From: Hoellman, Jordan
Sent: Wednesday, May 25, 2016 8:32 AM
To: Vogle PEmails
Subject: Non-Proprietary Slides for LAR 90 Structural Design of Auxiliary Building Floors
Attachments: 2016-05-26 LAR-090 NRC Presentation Slides (Non-Proprietary).pdf

Structural Design of Auxiliary Building Floors (WEC LAR-90)

1. Finned Floor Steel Plate Design Variations
2. Application of Design Details to Other Locations
3. Finned Floor Steel Plate Panels
4. Relocate HVAC Penetrations
5. Design of Floor to Wall Connection
6. Design of Concrete on Steel Plate Floors and Floor to Wall Connection
7. Update MCR Ceiling Design Summary
8. Fire Protection Reinforcement
9. Precast Panel Width and Stirrups

Existing Figure 3H.5-9, Sheet 1

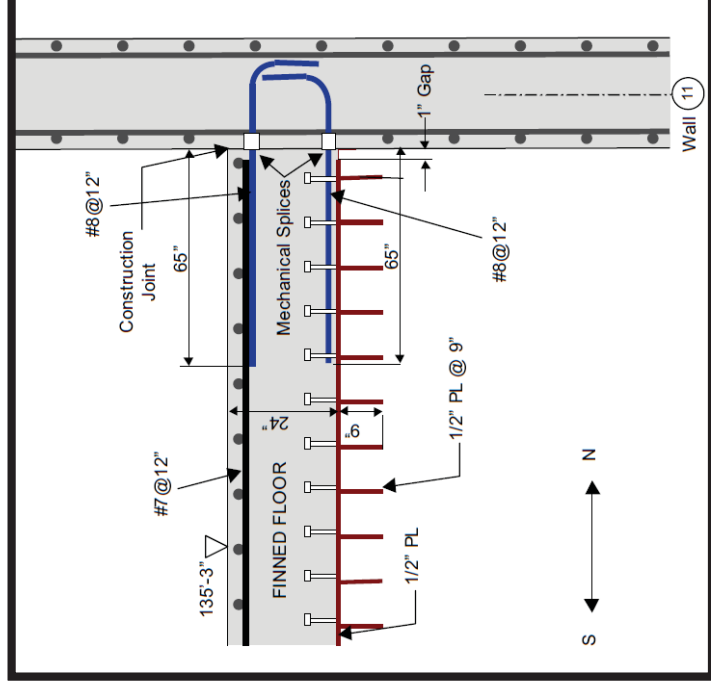
- UFSAR Figure 3H.5-9 shows a critical section and is identified as “**typical**” of the finned floor design.
- Figure is based on the detail design of the floor above the MCR
- The design details of the floor above the instrumentation and control rooms vary from that shown
- Changes are proposed to explain the variances

- Specify that the design details at locations other than above the Main Control Room and near penetrations and other interferences may vary from that shown in UFSAR Figure 3H.5-9.
 - Design remains in conformance with the design and analysis requirements found in ACI 349 and AISC N690
- Revise the critical section figure, UFSAR Figure 3H.5-9, to add notes about variations in the finned floor design and code requirements involved in the variations.
- The information added does not change the compliance of the finned floor design with codes and standards, including ACI 349 and AISC N690.
- The variations in the structural design details have no impact on passive heat sink function of the fins.

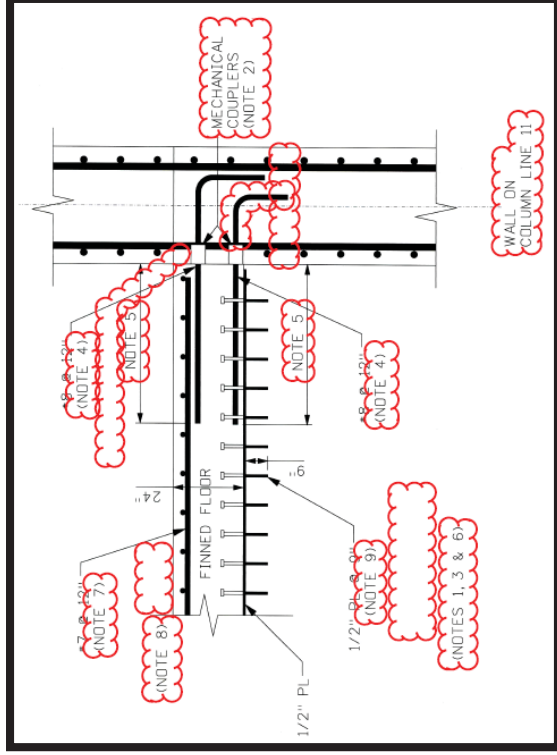
- Change to UFSAR Figure 3H.5-9, Sheet 2 to add notes to the figure:
 - State that the section shown is a specific location and other locations will have variations in design details.
 - State that headed reinforcement may be used.
 - Identify the requirements for development of headed reinforcement.
 - Identify the code requirements for reinforcement bar size and spacing

1. DETAIL SHOWN IS SPECIFIC TO THE REINFORCED CONCRETE FLOOR AT EL 135'-3" (MAIN CONTROL ROOM CEILING). REFER TO SUBSECTION 3H.5.4 AND OTHER NOTES FOR ADDITIONAL INFORMATION ABOUT DESIGN DETAILS FOR OTHER FLOOR SECTIONS AND FOR CONNECTIONS TO WALLS OTHER THAN THE WALL ALONG COLUMN LINE 11.

2. THE DEVELOPMENT OF THE FLOOR REINFORCEMENT IN THE WALLS CAN BE HEADED REINFORCEMENT INSTEAD OF STANDARD HOOKS.
3. REFER TO SUBSECTION 3.8.4.4.1 FOR THE REQUIREMENTS FOR DEVELOPMENT OF HEADED REINFORCEMENT.

4. REINFORCEMENT SIZE AND SPACING FOR CONNECTING DOWELS ARE BASED ON THE REQUIREMENTS IN ACI 349 AND ACI 318-11, SECTION 12.6. THE RANGE OF REINFORCEMENT SIZE AND SPACING FOR THE CONNECTING DOWELS VARIES FROM #8@12" TO #11@12". FOR THE SECTIONS ON ELEVATION 117'-6" SOME CONNECTING DOWELS RUN INTO ADJACENT REINFORCED CONCRETE FLOORS INSTEAD OF CONNECTING TO HOOKS OR HEADED REINFORCEMENT IN THE WALL. WHERE FINNED FLOORS ARE ADJACENT TO THE REINFORCED CONCRETE PORTION OF THE SHIELD BUILDING WALL THE FLOOR REINFORCEMENT CONTINUES INTO THE WALL INSTEAD OF USING SEPARATE CONNECTING DOWELS.

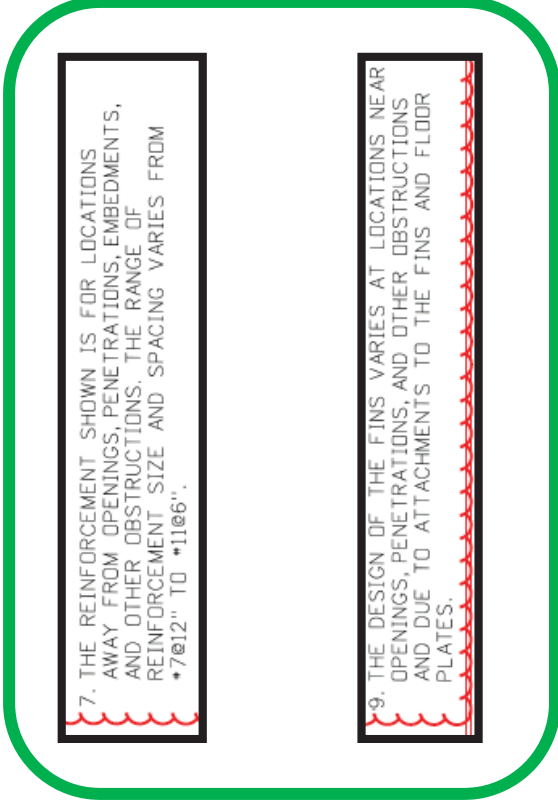
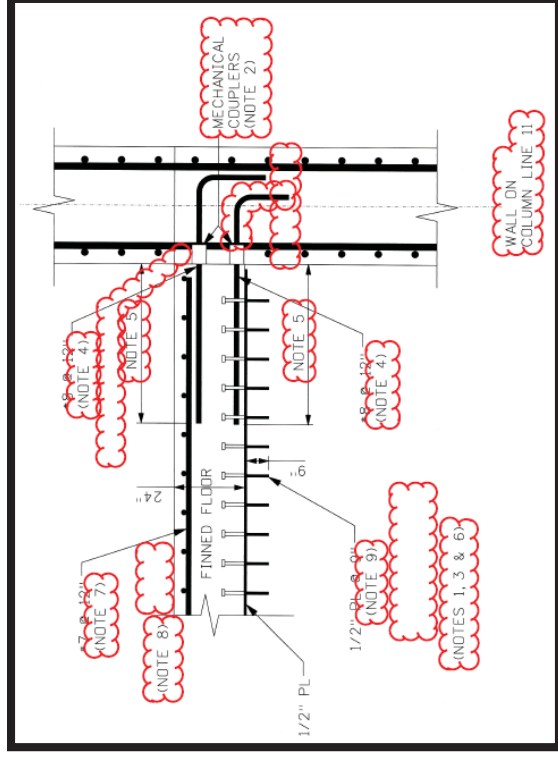
- Change to UFSAR Figure 3H.5-9, Sheet 2 to add notes to the figure:
 - State that the reinforcement shown is for locations away from obstructions.
 - State that the design of the fins varies at locations near obstructions and due to attachments to the fins and floor plates.

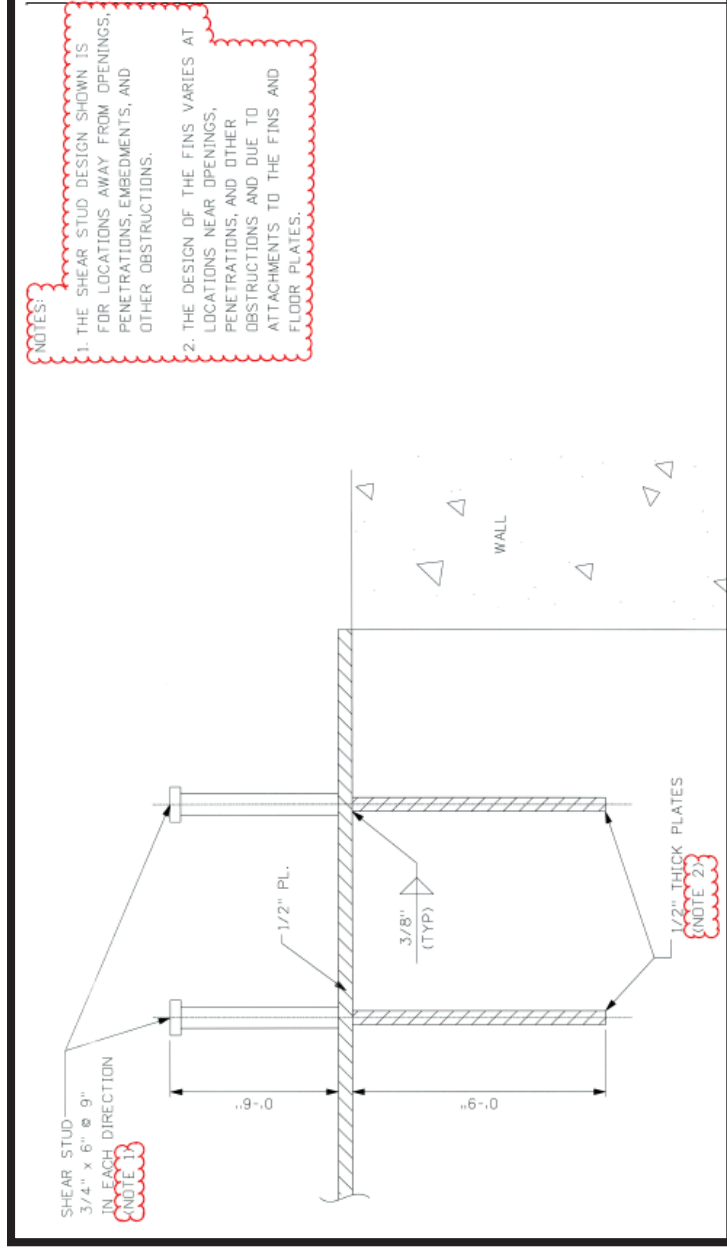
- Change to UFSAR Figure 3H.5-9, Sheet 3 to add notes to the figure:
 - State that the shear stud design shown is for locations away from obstructions.
 - State that the design of the fins varies at locations near obstructions and due to attachments to the fins and floor plates

- Figure 3H.5-9, Sheet 2 - Remove designation of 135'-3" elevation; replace with Note 8 elevation; replace with Note 8

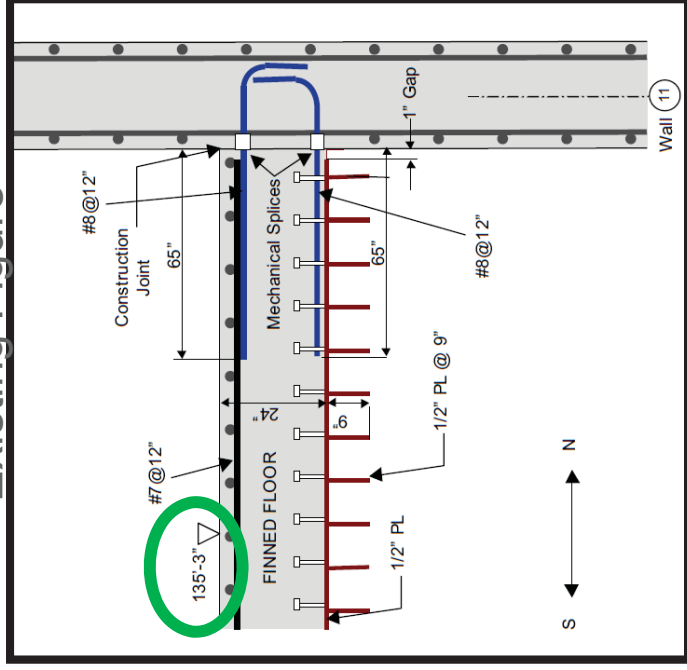
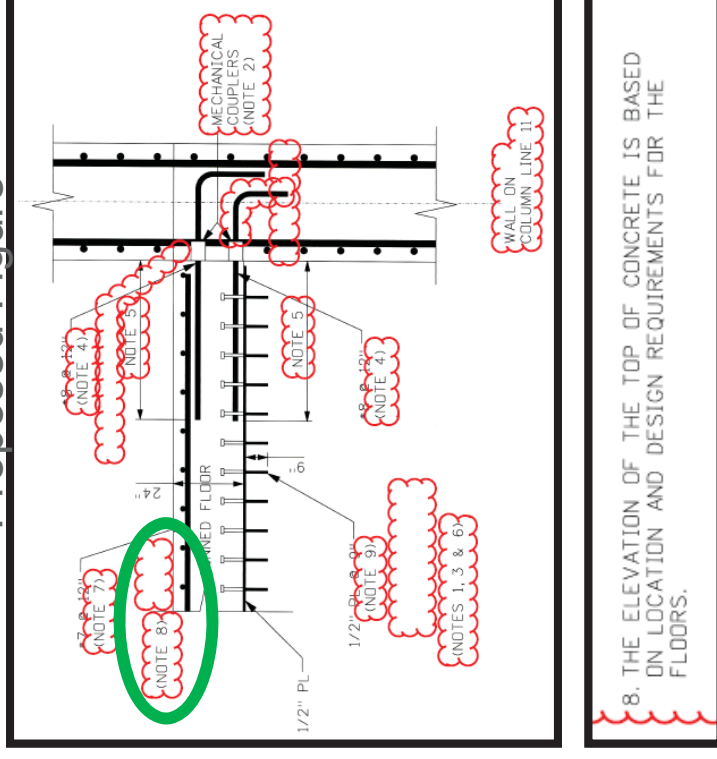
- The text in UFSAR Subsection 3.8.4.1.2 describes the finned floors in the Auxiliary Building and could be interpreted to indicate that UFSAR Figure 3H.5-9 is also typical of the details for the ceiling of the instrumentation and control rooms (floor at Elevation 117'-6").
- The design of the finned floor at El. 117'-6" does not exactly match the design details shown in the figure.
- Changes to the text in UFSAR are needed to acknowledge the variances.

- Revise the text in UFSAR Subsection 3.8.4.1.2 to allow variation in design details for locations other than the floor above the Main Control Room.
- Revise UFSAR Figure 3H.5-9 Sheet 2 to remove elevation designation.
- The Auxiliary Building floors designed as finned floors continue to maintain compliance with codes and standards, including ACI 349 and AISC N690.

- Revise Figure 3H.5-9, Sheet 1 to show five finned floor steel plates between Column Lines 9.2 and 11 from Column Lines I to L.

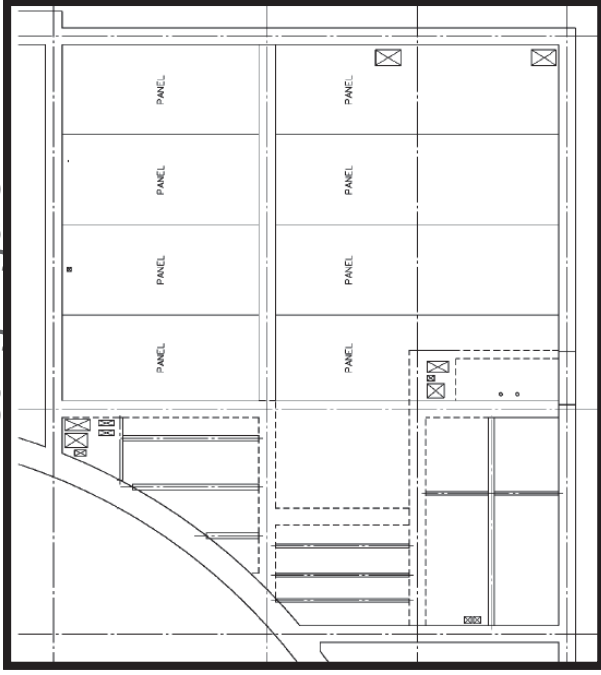
- UFSAR Figure 3H.5-9 (Sheet 1 of 3) shows four finned floor steel plates (panels) between Column Lines 9.2 and 11 from Column Lines I to L.
- It is proposed that the number of plates between Column Lines 9.2 and 11 be increased to facilitate fabrication and construction.

- Add information to UFSAR Subsection 3.8.4.1.2 to note that the number of panels may vary.
- Revise UFSAR Figure 3H.5-9, Sheet 1 to increase the number of panels to five and add a note that the number of the panels will vary at other locations.
- The change and variation in number and width of panels does not change the compliance of the finned floors design with codes and standards, including ACI 349 and AISC N690.
- The variations in the number and size of the panels have no impact on passive heat sink function of the fins.

2. THE NUMBER OF STEEL PANELS USED TO CONSTRUCT THE FLOOR IS DETERMINED BY THE SIZE OF THE ROOM AND FABRICATOR CAPABILITIES.

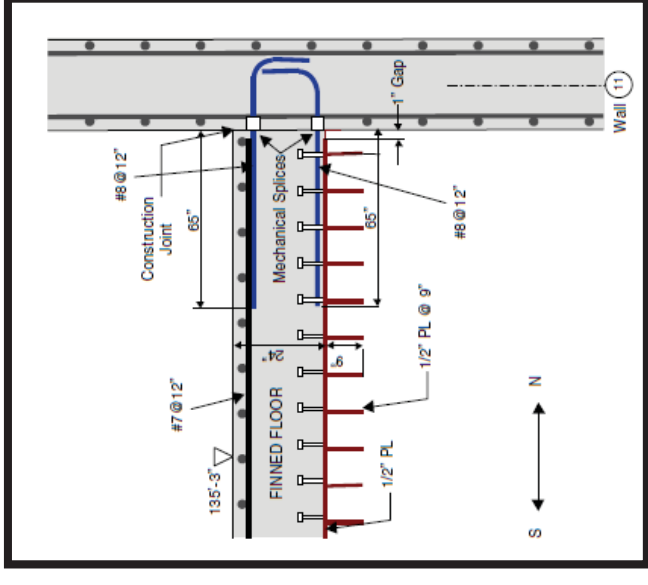
- Openings for HVAC ducts in the ceiling of the Main Control Room are shown in the finned floor critical section figure UFSAR Figure 3H.5-9 Sheet 1.
- A proposed change relocates these openings on the figure because of rerouting of the HVAC ducts.
- The openings are moved out of the floor above the Main Control Room to the floor above another room within the control room envelope.
- In addition openings shown on the left side of the figure adjacent to Column Line 9.2 are reconfigured because of final design changes in routing.

- Revise Figure 3H.5-9, Sheet 1 to move the rectangular openings for HVAC ducts from along Column Line 11 near Column Lines I and J to along Column Line L near Column Line 11

- Revise UFSAR Figure 3H.5-9, Sheet 1 to show the openings for HVAC ducts in the relocated position.
- The relocated penetrations and the reconfigured openings adjacent to column line 9.2 have no adverse impact on the finned floor design and evaluation.
- The structural evaluation of the floor includes the relocated and reconfigured openings and is in compliance with ACI 349 and AISC N690.

- Figure 3H.5-9, Sheet 2
 - Revise figure to show both hooks in wall turned down

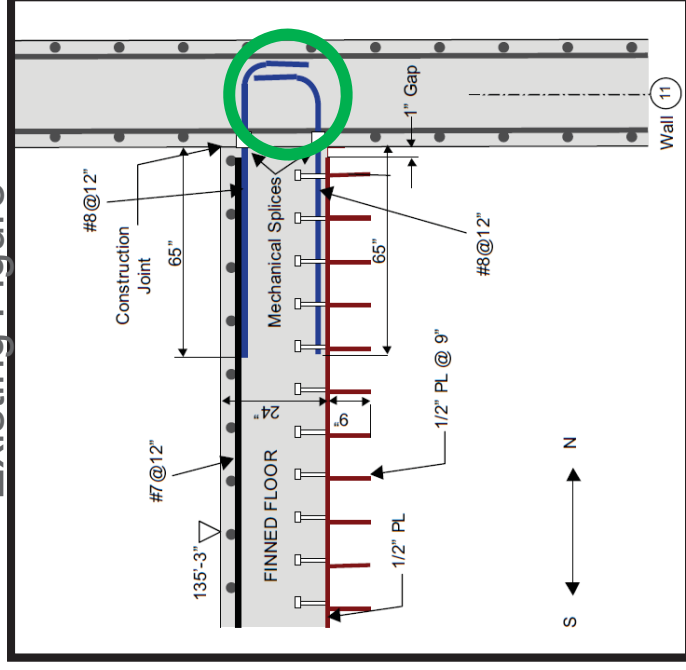
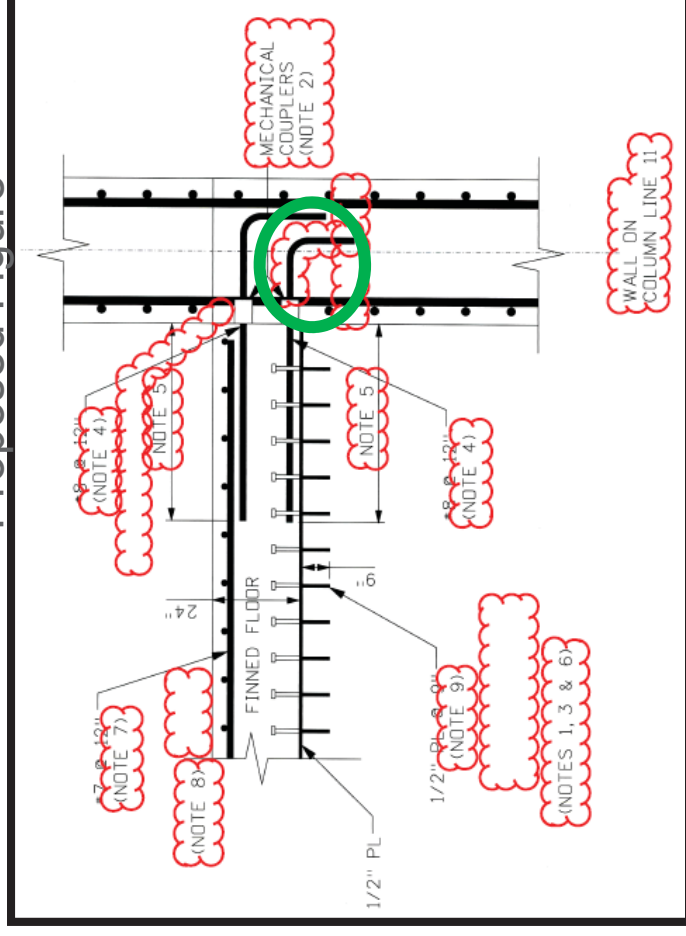
- Proposed design changes are identified to the detail reinforcement design of the finned floor to wall connection shown in UFSAR Figure 3H.5-9 Sheet 2 to be consistent with common AP1000 construction practice.

- Revise UFSAR Figure 3H.5-9 Sheet 2 to show the proposed detail reinforcement design of standard hooks both turning down in the wall.
- Remove the designation of the construction joint shown between the floor and wall and the gap between the steel plate and the wall because these elements may vary based on fabrication considerations and construction sequence.
- The North – South designator is removed as it is not needed.
- The designation of Wall 11 is changed to “Wall on Column Line 11” instead of using the drafting convention currently shown because the current designation may be confusing.
- The term “mechanical splice” is change to “mechanical coupler”

- Figure 3H.5-9, Sheet 2
 - Add note to discuss bottom layer reinforcing steel provides for structural integrity of the fire barrier.

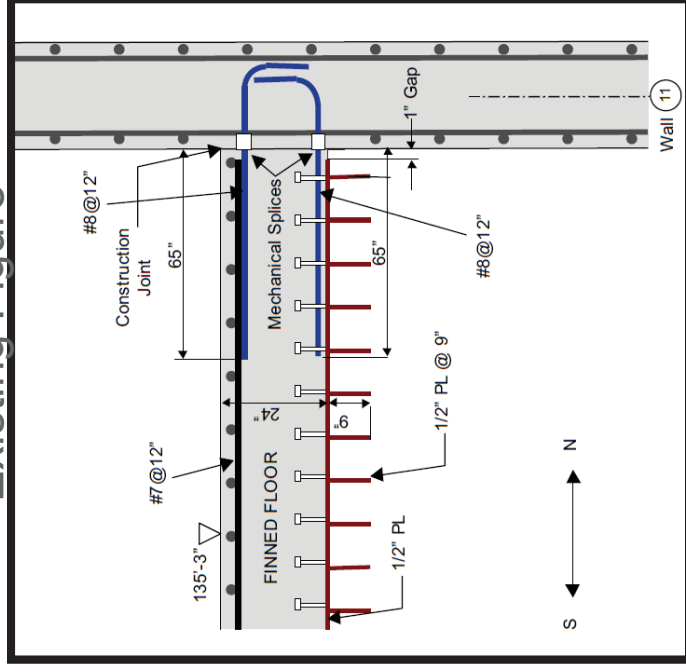
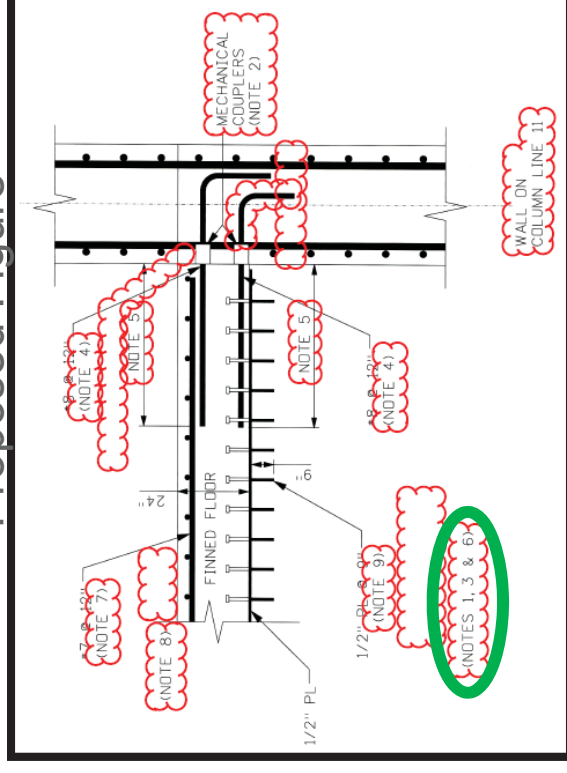
- The AP1000 fire hazard analysis credits the floors above the instrumentation and control rooms as 3-hour fire barriers.
- Additional bottom layer reinforcing steel is required in the floors at the 117'-6" elevation to maintain the structural integrity of the fire barrier during a fire event due to potential deterioration of mechanical properties of exposed steel fin plates during the fire.
- This reinforcement is not shown or described in the UFSAR text or figures.

6. ADDITIONAL BOTTOM LAYER REINFORCING STEEL IS PROVIDED IN THE FINNED FLOORS AT ELEVATION 117'-6" WHERE NEEDED TO MAINTAIN THE STRUCTURAL INTEGRITY OF THE FIRE BARRIER.

- UFSAR Figure 3H.5-8
 - Revise to show the width of the precast panels to be 6'-4 1/2".

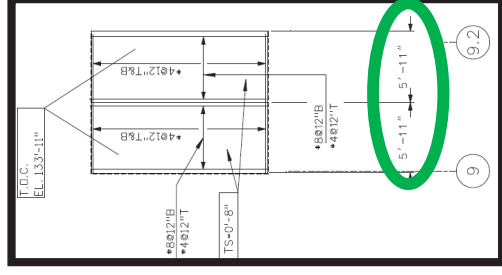
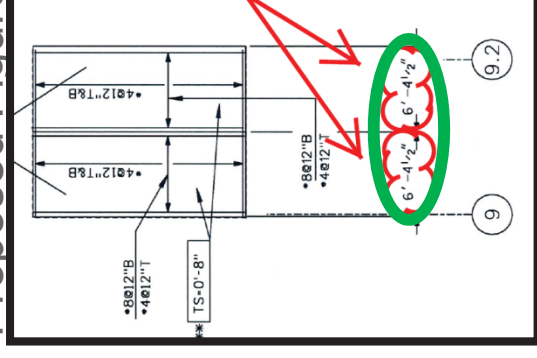
- Subsection 3H.5.3.1 describes and UFSAR Figure 3H.5-8 shows the design of the critical section for reinforced concrete floors constructed of cast-in-place concrete over precast panels
 - Current UFSAR width of the precast concrete panels is 5'-11"
 - Proposed to change the width of the panels to 6'-4 1/2" to fully cover the room below
- Figure 3H.5-8 shows three double stirrups connecting the precast panel to the cast-in-place concrete.
 - The proposed design change for this section proposes to add a single stirrup for the wider panel to satisfy ACI 349, Chapter 17 requirements and the orientation of the hooks on the top of the stirrup being in the plane of the stirrup to facilitate fabrication.

*The two precast concrete panels, each ~~5'-11"~~ 6'-4 1/2" wide and spanning over 16'-0" clear span, are installed to serve as the formwork.]**
